# Access Compliance Report

## Public Rights-of-Way

### (Curb Ramps)

Intersection ID: 14724	Main Street: ALBEMARLE_RD	Cross Street: GUICE_CROSSING_LN	Location: NW
ADA ID: D78955925405	Ramp Type: Perp	Initial Pass/Fail: Fail	Overall Compliance: No
Severity Score: 8.75			
Codes/Mitigation Info/Possible Solution		Field Measurements/Component Compliance

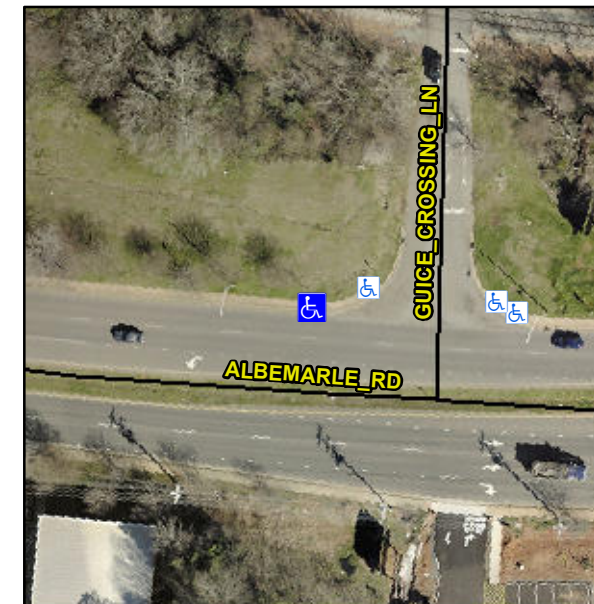
**Not Found, R304.5.1**

Compliance	Description	Data	Compliance	Description	Data
N/A	Ramp Length (in)	60.0	Yes	Ramp Slope (%)	7.1
No	Ramp Width (in)	47.5	Yes	Ramp XSlope (%)	1.6
N/A	Flare Type LT	N/A	N/A	Flare Type RT	N/A
N/A	Flare Slope LT (%)	N/A	N/A	Flare Slope RT (%)	N/A
N/A	Flare Traversable LT?	N/A	N/A	Flare Traversable RT?	N/A
N/A	Landing Length (in)	N/A	N/A	DWS Provided?	N/A
N/A	Landing Width (in)	N/A	N/A	DWS Contrast?	N/A
N/A	Landing Slope (%)	N/A	N/A	DWS Length (in)	N/A
N/A	Landing X Slope (%)	N/A	N/A	DWS Full Width?	N/A
N/A	Landing Curb? (Y/N)	N/A	N/A	DWS Offset (in)	N/A
N/A	Shared Landing?	N/A			
N/A	Gutter Ponding?	N/A	N/A	Gutter Slope (%)	N/A
N/A	Gutter Lip Ht (in)	N/A	N/A	Gutter X Slope (%)	N/A
N/A	Painted X Walk1?	No	N/A	Painted X Walk2?	N/A
	X Walk 1 Direction	To S		X Walk 2 Direction	N/A
N/A	X Walk 1 Width (in)	N/A	N/A	X Walk 2 Width (in)	N/A
	X Walk 1 Slope (%)	1.7		X Walk 2 Slope (%)	N/A
	X Walk 1 X Slope (%)	1.2		X Walk 2 X Slope (%)	N/A

**Remove & Replace Entire Ramp.**
